Wellington South Battery Energy Storage System

Amendment Report

J210534 RP1

July 2023

Wellington Battery Energy Storage System
Amendment report
Figure 3.1

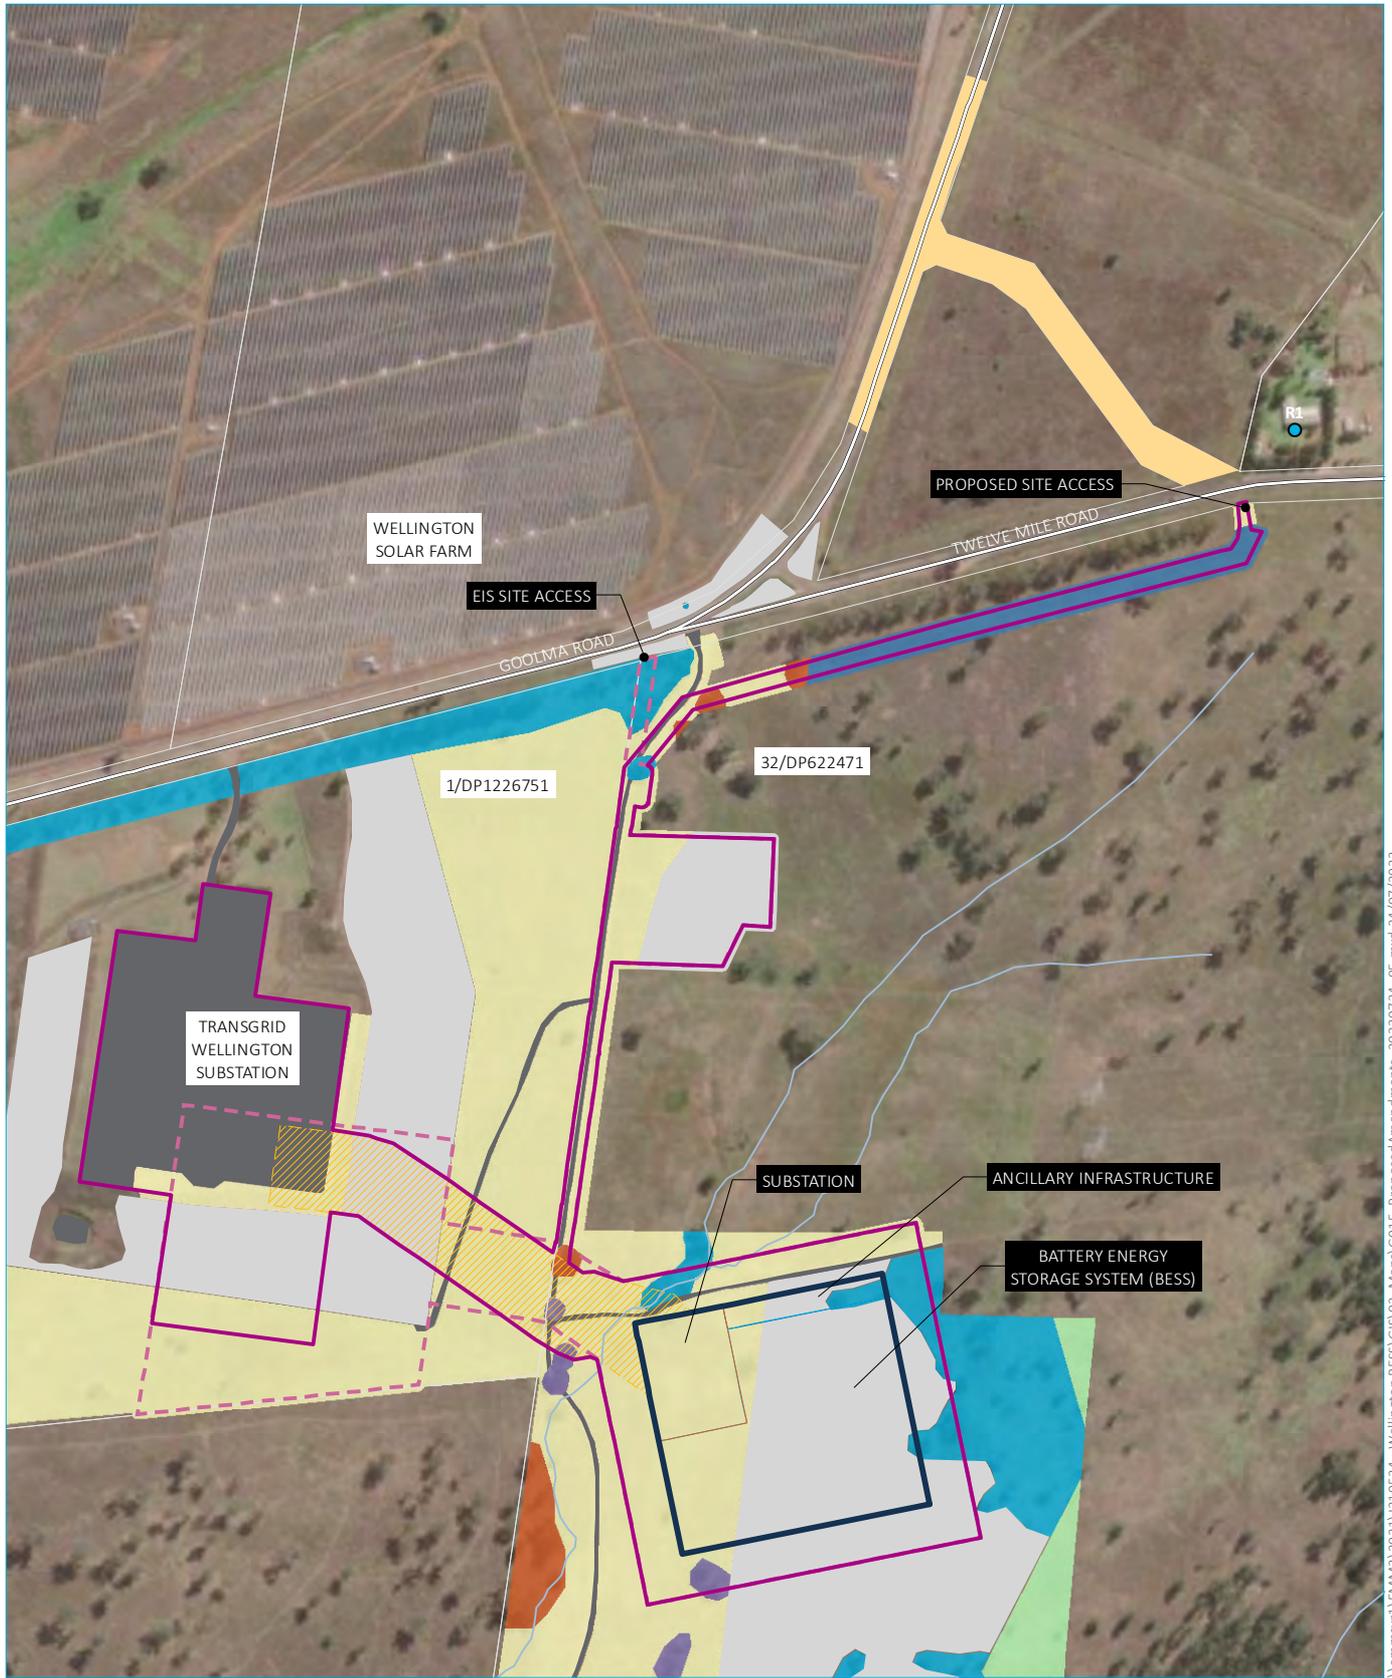
An alternate access via Twelve Mile Road was identified as the preferred option as illustrated in Figure 3.1. The internal access road will extend east of the washdown bay, parallel with Twelve Mile Road before connecting to Twelve Mile Road. This site access is proposed to be utilised for construction, operation and decommissioning of the project.

In consultation with TransGrid, the transmission connection layout has been subject to minor revision, as shown in Figure 3.1. This includes a slight realignment of the connection infrastructure and reduction in the disturbance area associated with the upgrade of TransGrid's substation. The corridor width remains the same, at 75 m, to allow for a sufficient buffer area either side of the transmission lines.

The development boundary has also been amended to include the full extent of the existing TransGrid Wellington Substation footprint (refer to Figure 3.1) as part of the further advancements with the detailed design of the project.

Wellington Battery Energy Storage System
 Addendum noise assessment -
 Alternate access arrangement
 Figure 2.2

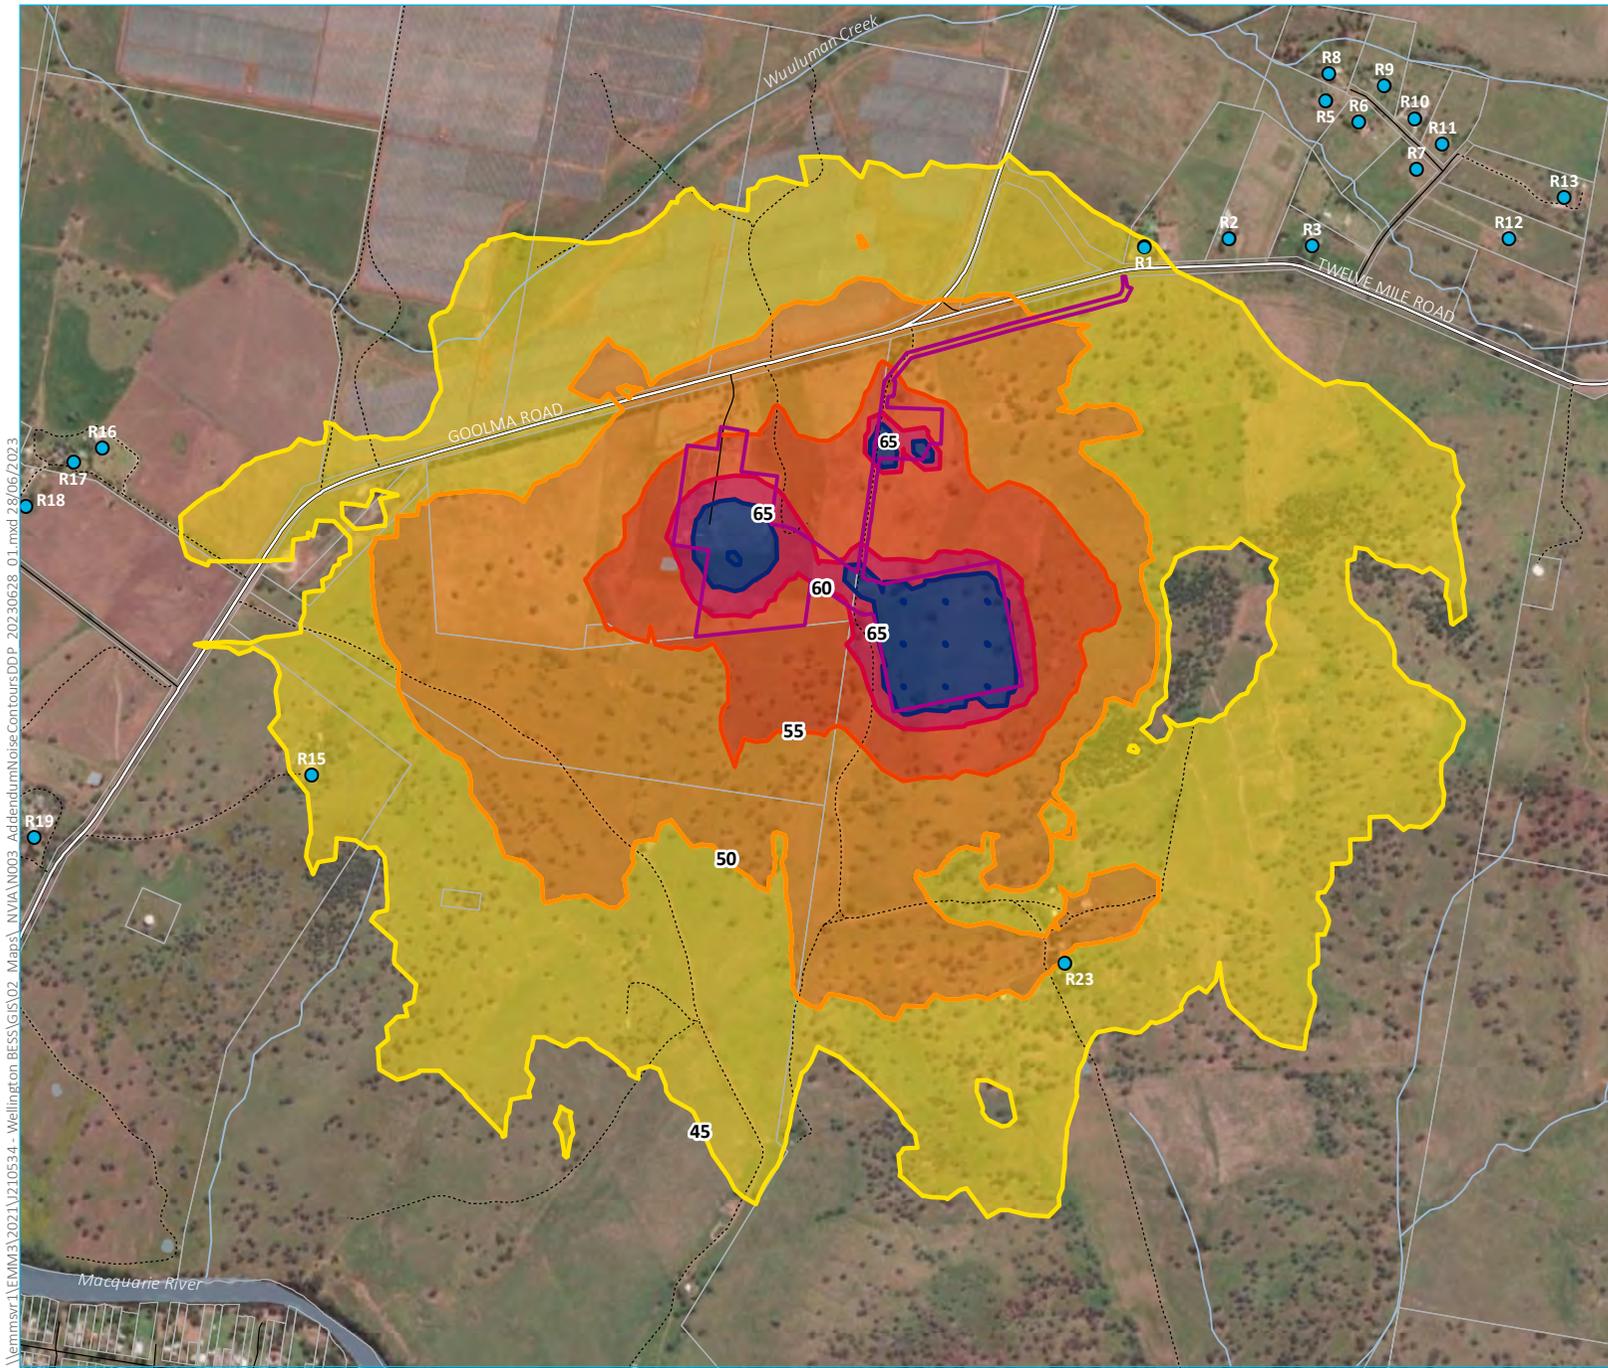
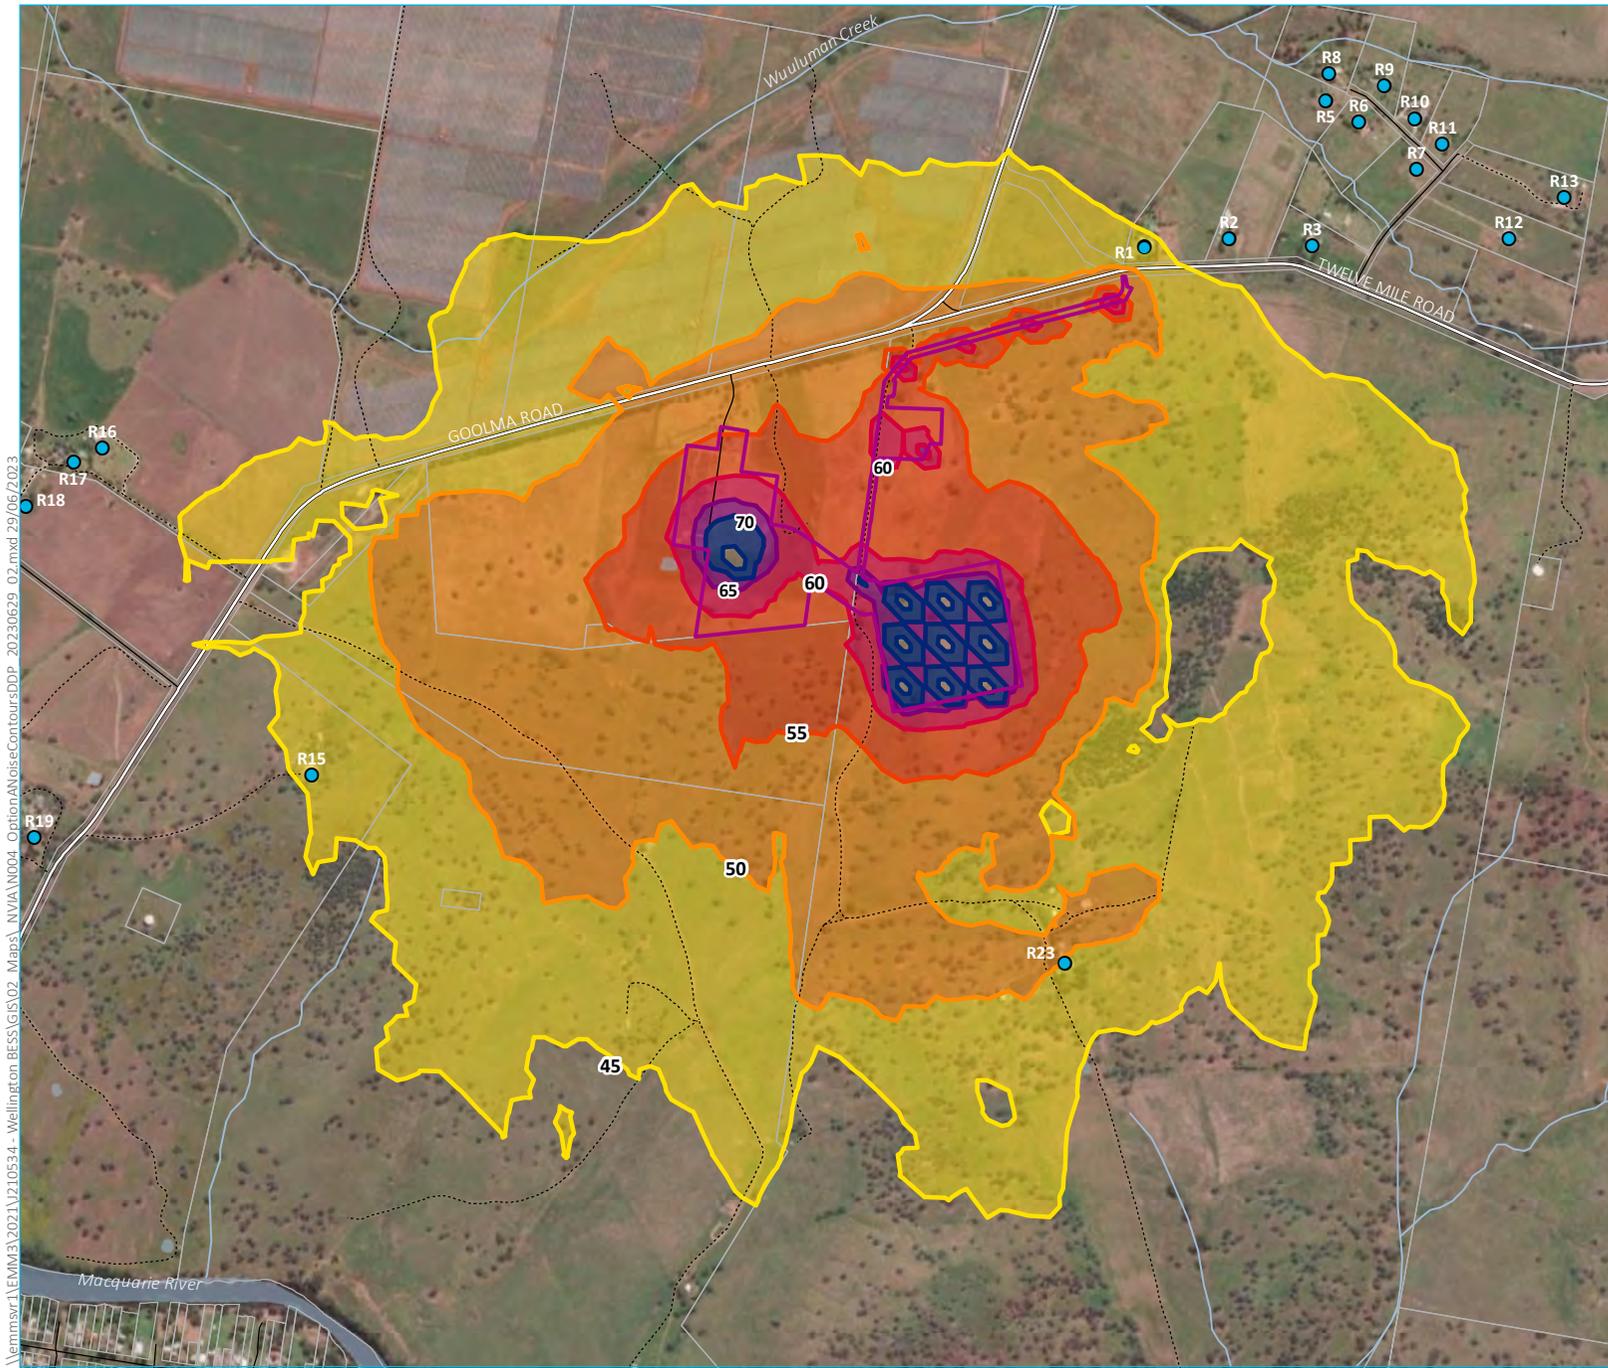
Predicted $L_{Aeq,15\text{minute}}$ noise contours representing the worst-case noise level footprint from the Phase 1 project construction is provided Figure 2.1 (EIS NVIA) and Figure 2.2 (Twelve Mile Road access). The figures represent the predicted construction noise levels under noise enhancing conditions. The contours indicate a limited increase in exposure of construction noise of a negligible 1 dB.
